Standards Committee

Meeting Agenda

TITLE	Champion
1st time to Committee. Twenty (20) proposed drawings and revisions to WVDOH Standard details Book – Volume 2. The sheets are listed below. A summary of each sheets revisions are included in the meeting packet; and proposed sheets have revised areas highlighted yellow. a) <i>TE1-3A Roadside Sign Supports Steel Beam Type</i> b) <i>TE1-3B Roadside Sign Supports Steel Beam Type</i> c) <i>TE1-3C Roadside Sign Supports Steel Beam Type</i> d) <i>TE2-1A Bridge or Retaining Wall Sign Mounting, Type K 1 & 2 Supports</i> e) <i>TE2-1B Bridge or Retaining Wall Sign Mounting, Type K 1 & 2 Supports</i> f) <i>TE2-2 Bridge or Retaining Wall Sign Mounting, Type L Pipe Post Mount</i> g) <i>TE2-3 Barrier Wall Sign Support Bracket Type D</i> h) <i>TE3-1 Overhead Sign Support – Steel Two Tube Span (TTS)</i> i) <i>TE3-2 Overhead Sign Support – Steel One Tube Span (OTS)</i> j) <i>TE4-3A Overhead Sign Support – Steel Double Arm Cantilever</i> k) <i>TE4-3B Overhead Sign Support – Butterfly Cantilever</i> l) <i>TE4-4A Overhead Sign Support – Single Arm Cantilever (Heavy)</i> m) <i>TE4-4B Overhead Sign Support – Single Arm Cantilever (Light)</i> n) <i>TE4-5

STANDARD SHEET TE4-3A

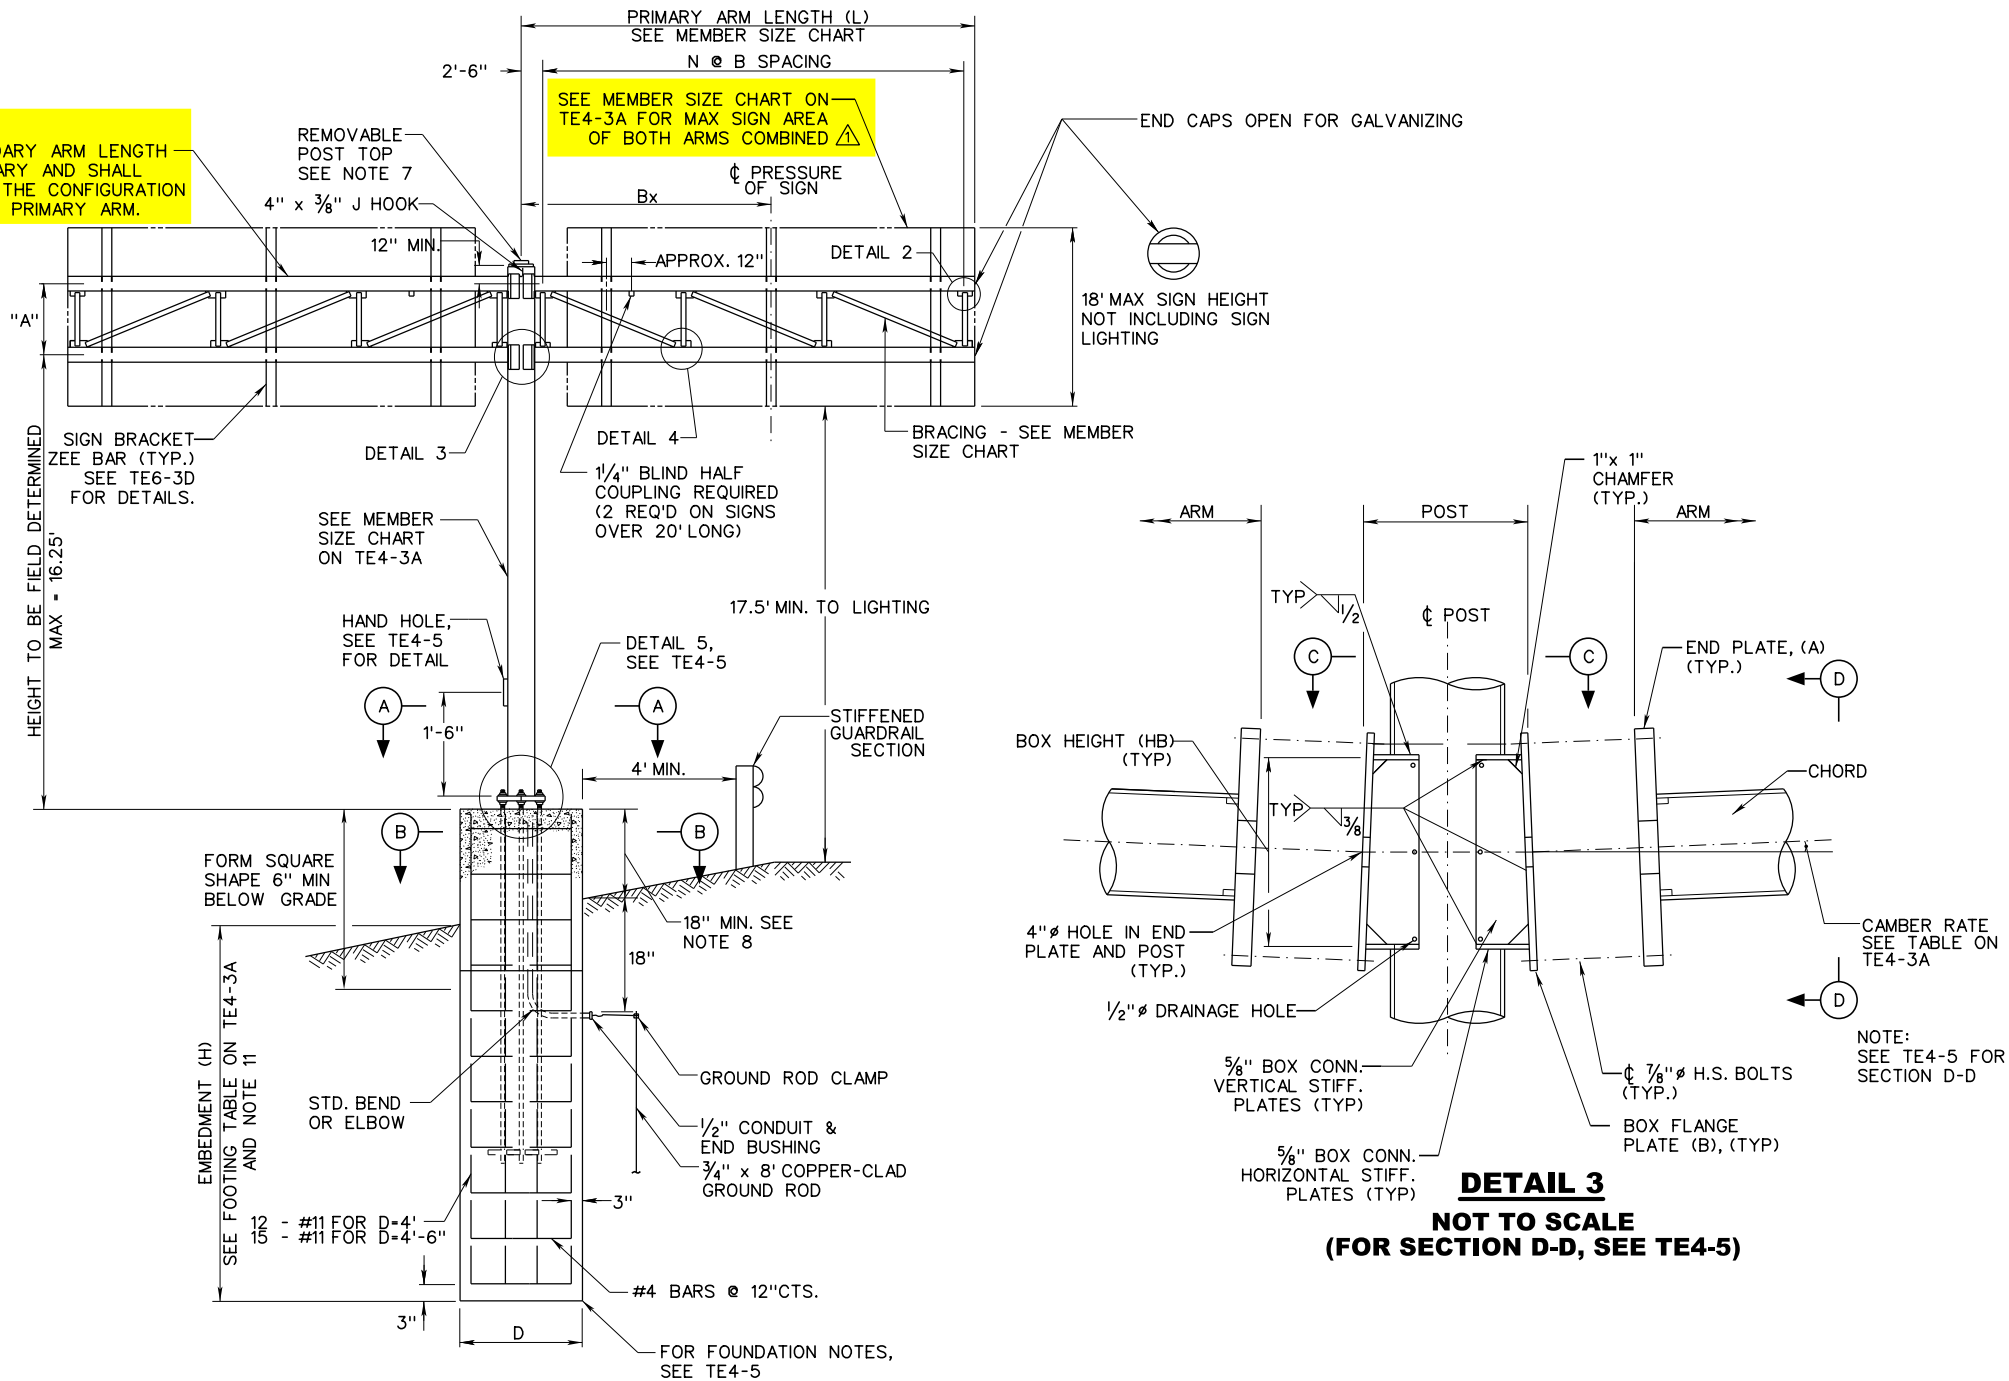
TE4-3A	1	2/22/2023	Added NPS to column headings and changed post to NPS in Member Size Chart. Revised plate dimensions and added max plate hole diameter to Footing Table. Revised end and box flange plates, revised bolt numbers for DAC-32 & DAC-40, and added Hole Diameter column to Box Connection Table.

REVISED MEMBER SIZE CHART, FOOTING TABLE, AND BOX CONNECTION TABLE

STANDARD SHEET TE4-3B

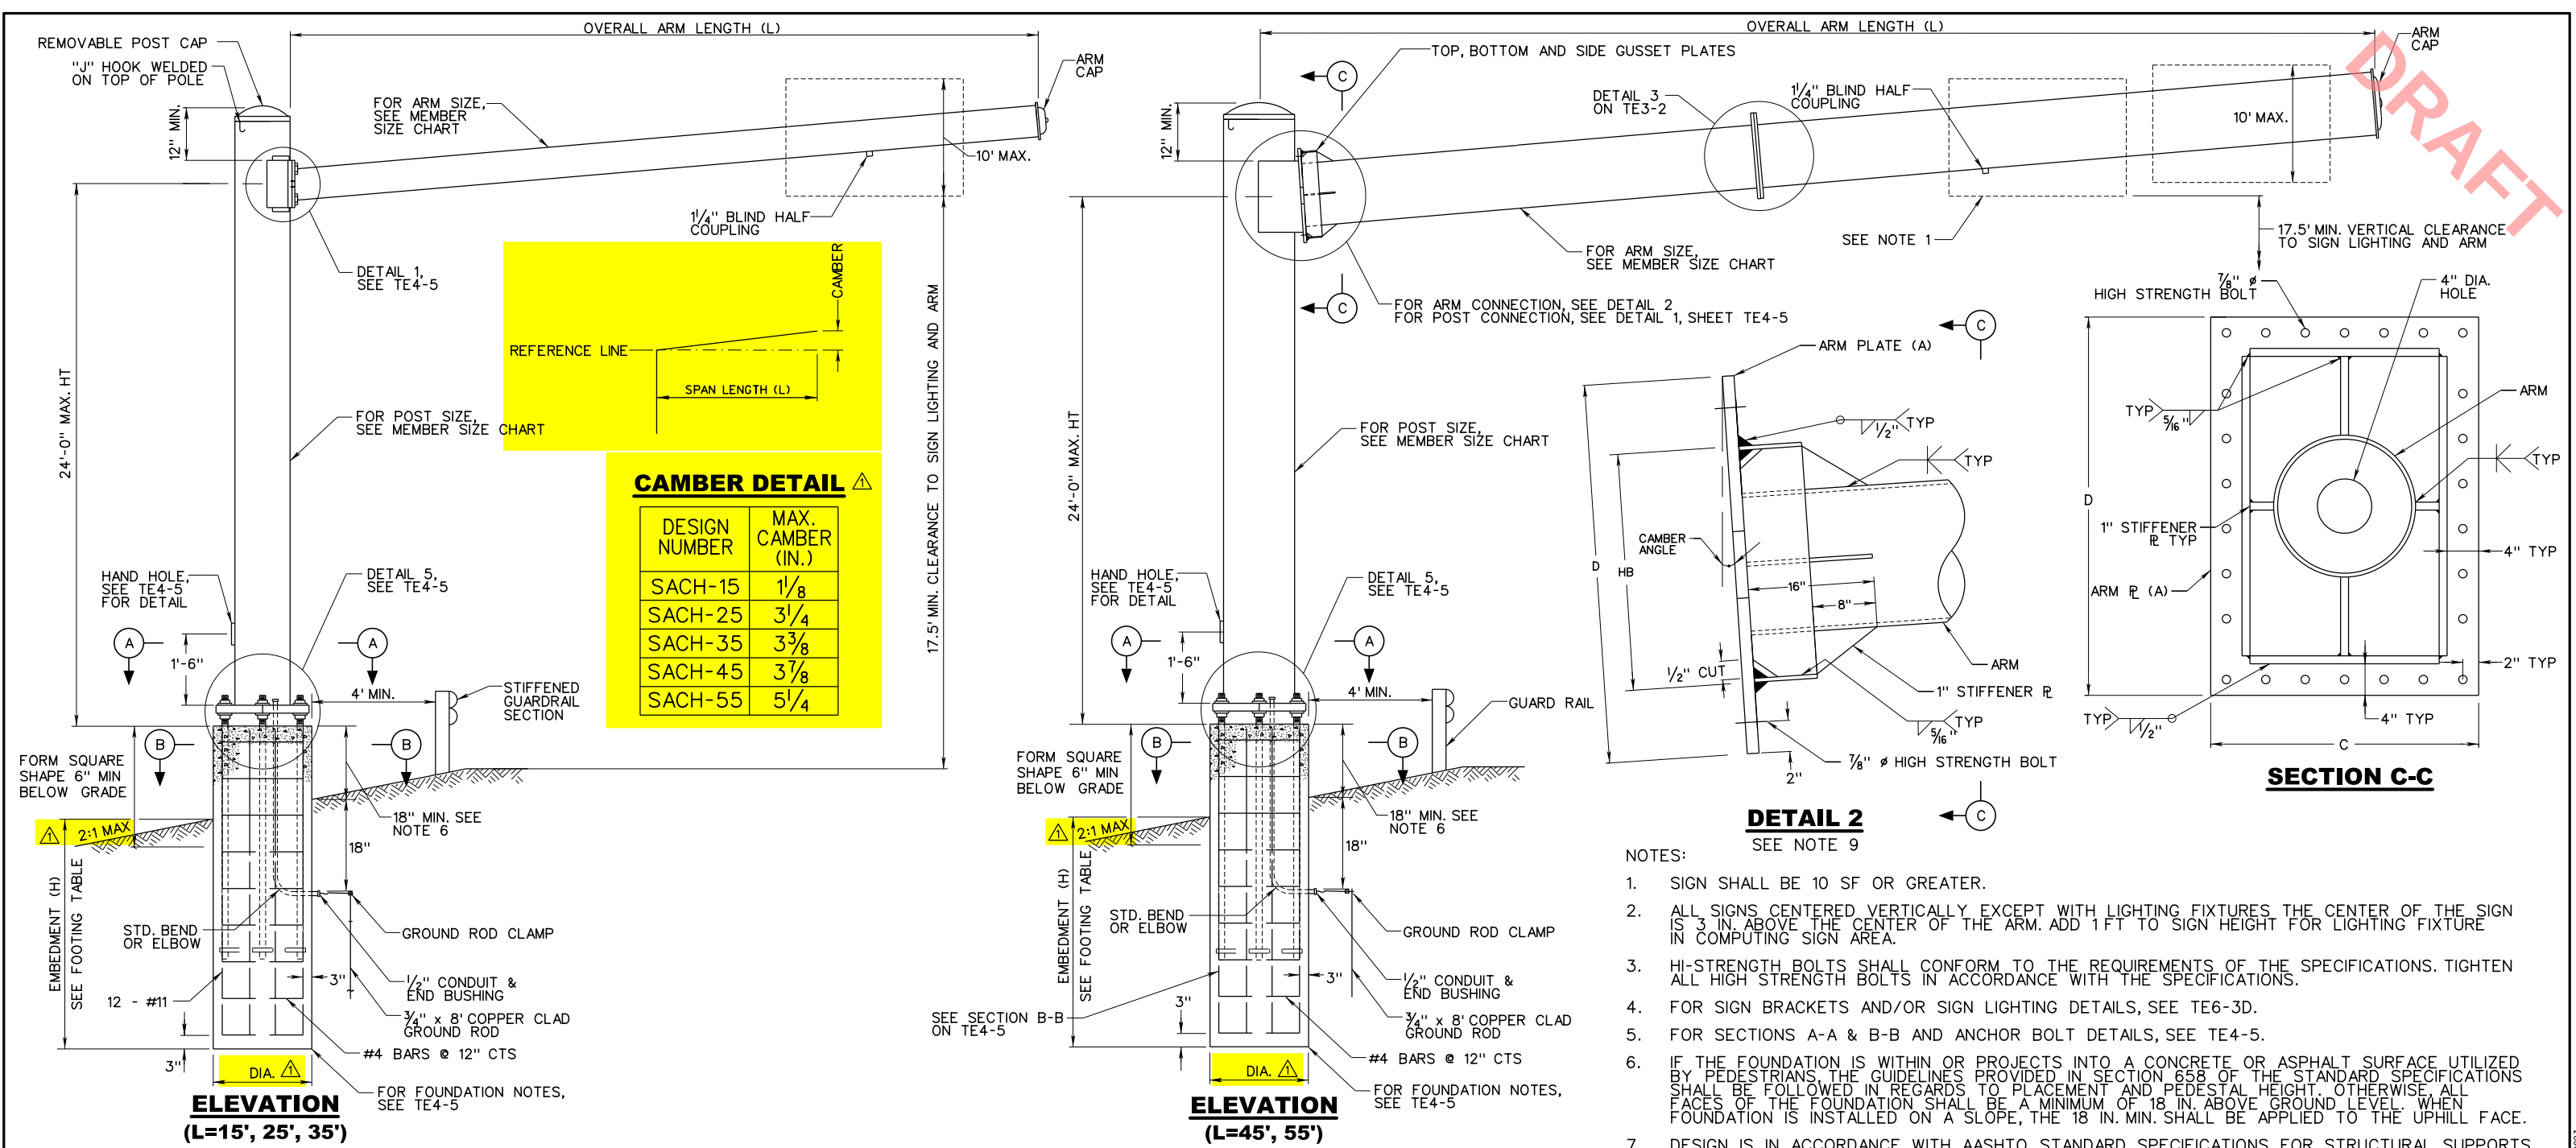
TE4-3B	1	2/22/2023	Revised rules for allowable sign area and secondary arm member sizes. Original version allowed max sign area for each arm, but that is incorrect.
TE4-4A	1	11/18/2022	Revised foundation diameter and embedment depth; moved diameter information to new column in Footing Table. Added design soil parameters and 2:1 max slope to Elevations. Added 'W' dimension to the Box Connection Table for SACH-15, 25 & 35 designs. Increased post sizes for SACH-45 & 55 designs in the Member Size Chart and corrected arm sizes in the Box Connection Table. Added base plate hole diameter column to Footing Table. Added camber information.
TE4-4B	1	9/2020	Added Moment Arm Calculation to aid in determining proper design for multiple smaller signs. Revised bolt hole diameter in the Footing Table. Added 'W' dimension and 'X' dimension (TE4-5) to the Box Connection Table. Added camber angle.
	2	5/2022	Revised Arm A and Arm B lengths and added Arm B diameters in Member Size chart.

⚠️ REVISED RULES FOR ALLOWABLE SIGN AREA AND SECONDARY ARM MEMBER SIZES

STANDARD SHEET TE4-4A

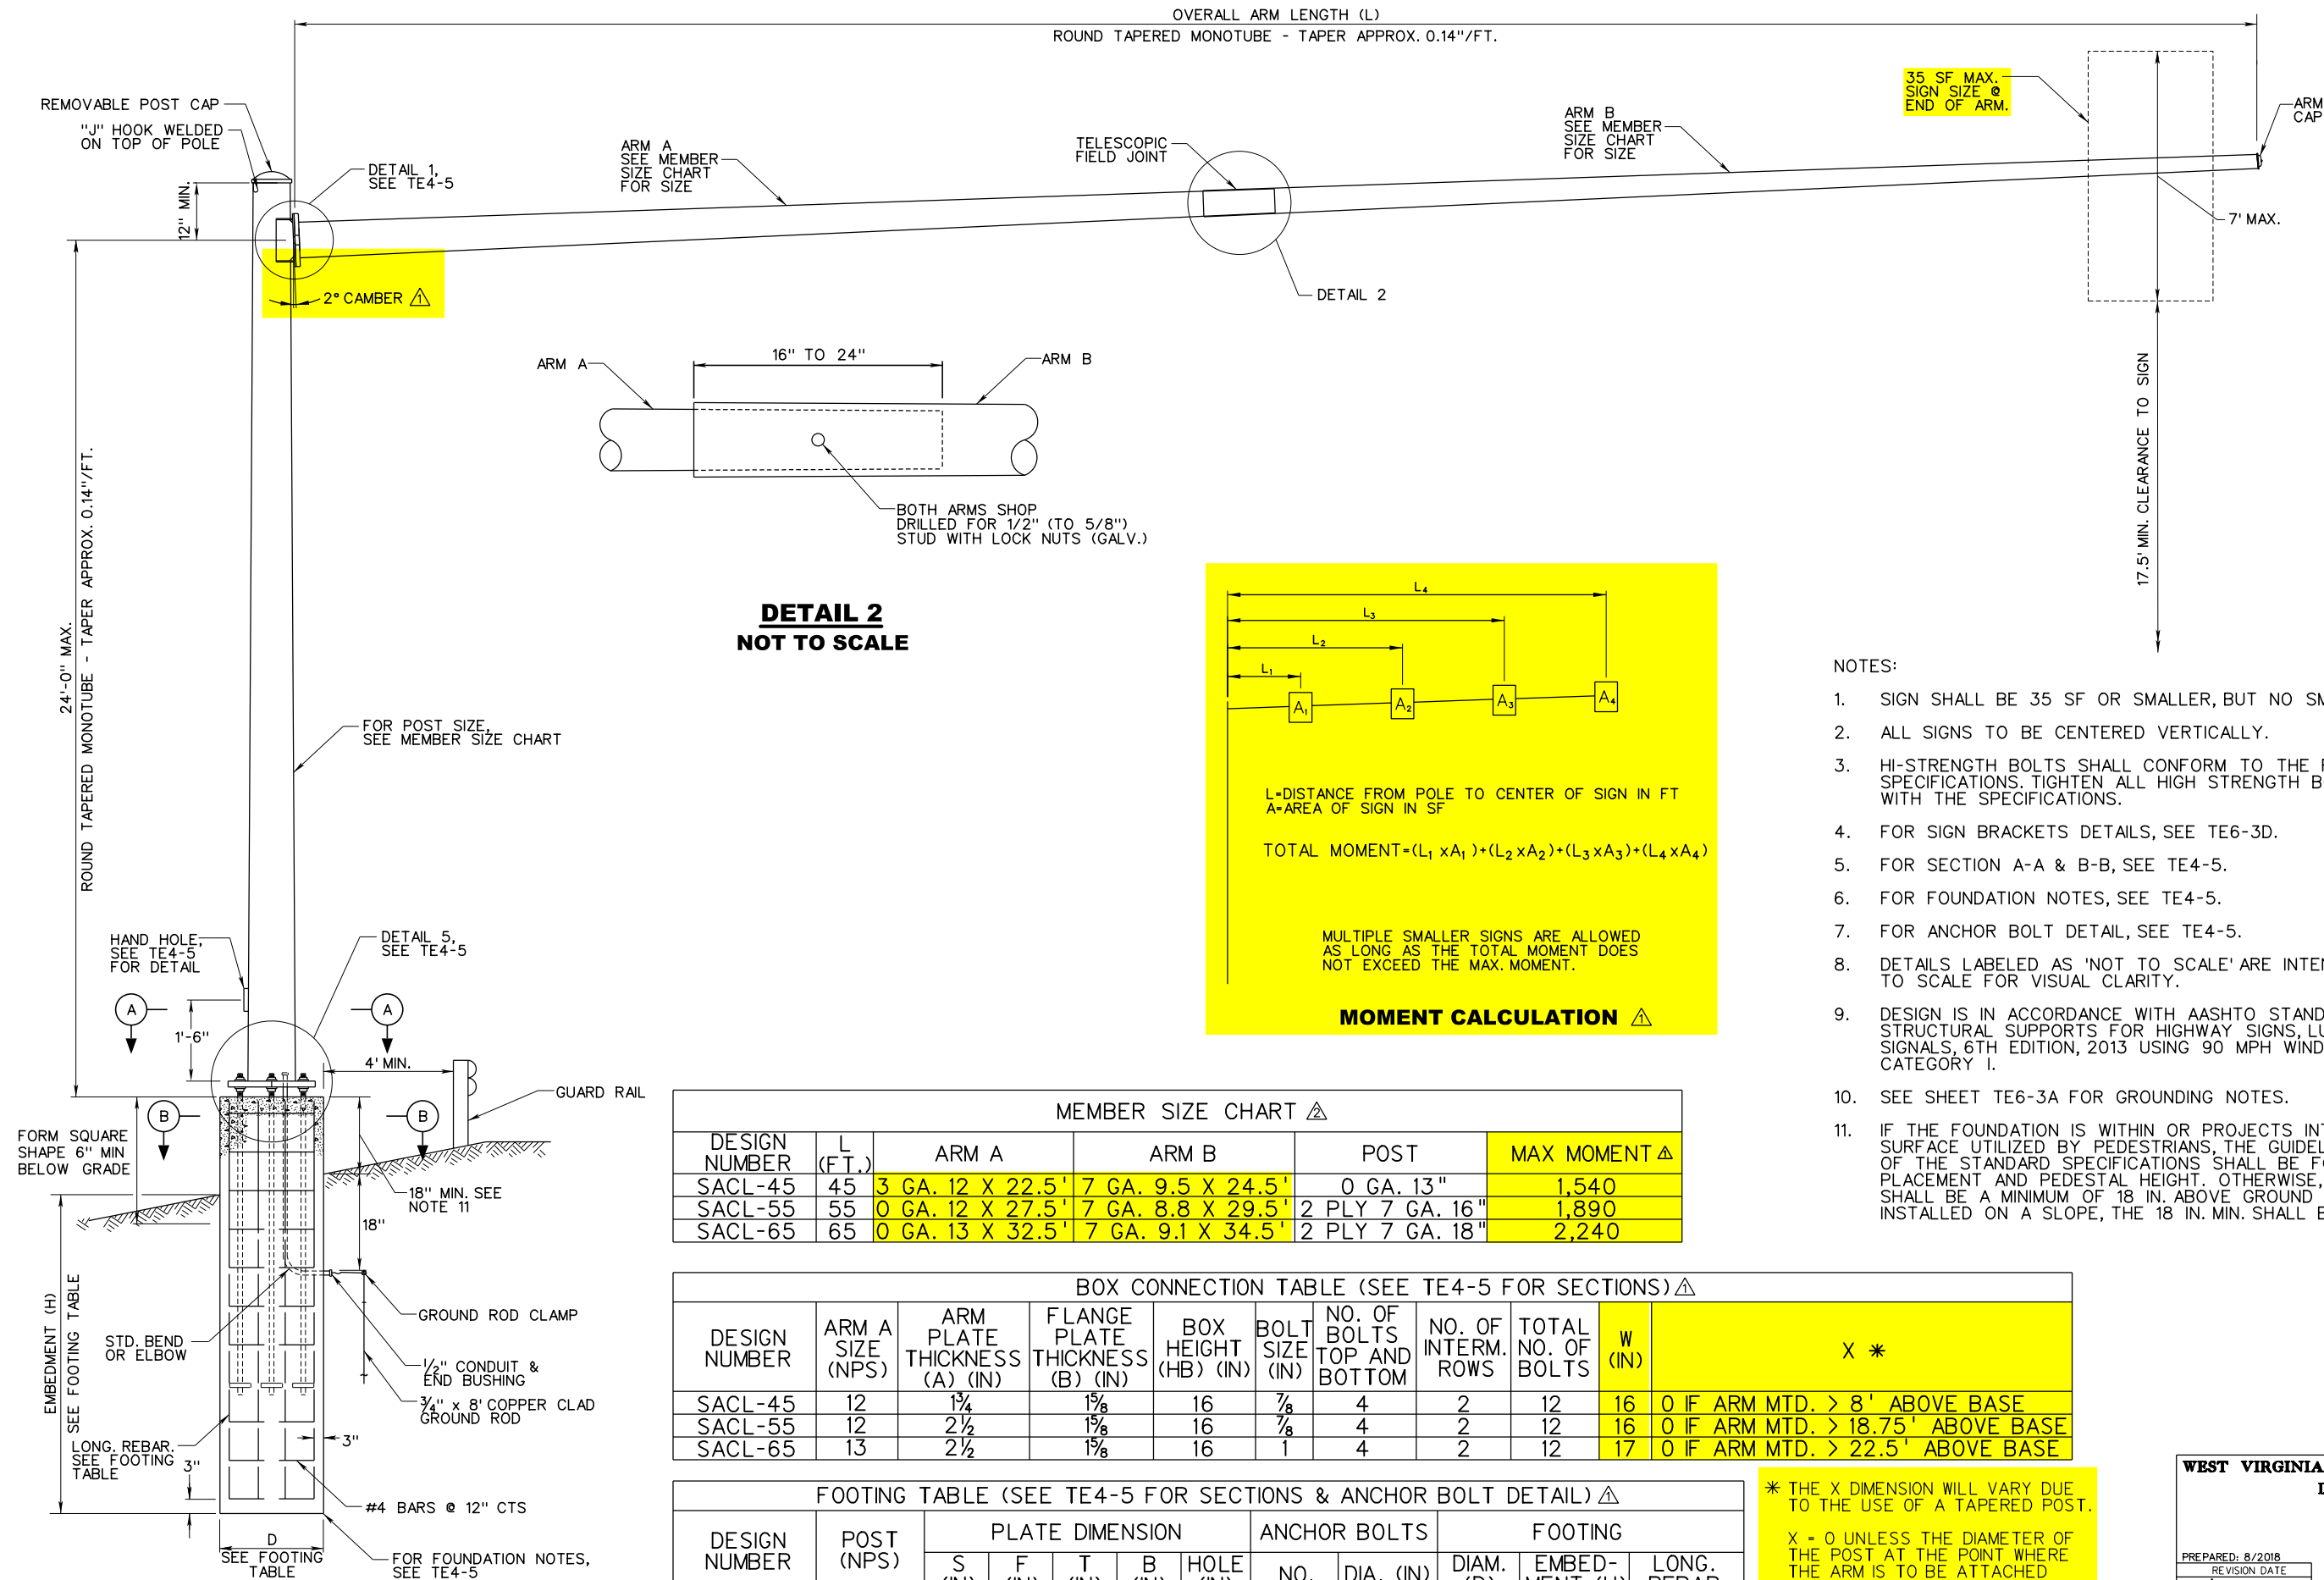
REVISED FOUNDATION DIAMETER AND EMBEDMENT DEPTH FOR 45' & 55' ARM LENGTHS. ADDED SOIL PARAMETER NOTE AND 2:1 MAX. ALLOWABLE SLOPE TO ELEVATIONS. REVISED BOX CONNECTION TABLE TO ADD W DIMENSION. REVISED POST AND ARM SIZES FOR 45' & 55' ARM LENGTHS AND AFFECTED BASE PLATE DIMENSIONS. MOVED FOOTING DIAMETER INFORMATION TO THE CHART. ADDED BASE PLATE HOLE SIZE INFORMATION. ADDED CAMBER DETAIL AND CHART.
